OPEN HOUSE NO. 2 SUMMARY

US 287 / South College Bicycle Lane Project
Harmony Road to Carpenter Road / LCR 32

US 287 / SOUTH COLLEGE AVENUE BICYCLE LANE PROJECT SECOND OPEN HOUSE COMMENT SUMMARY

Bike-and-chevron symbol

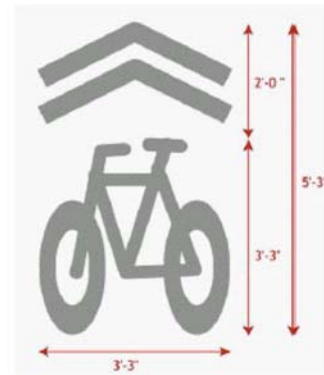
- **Signage:** Use reflective marking or yellow coloring for the bike under chevrons symbol. (1) The shared by cars and bikes signage does not provide clear information, do the chevrons over the bike mean "bike shelter"? Is the dashed arrow around the bike a "bike house"? Perhaps it would help to combine a car symbol with a bicycle and the word shared.
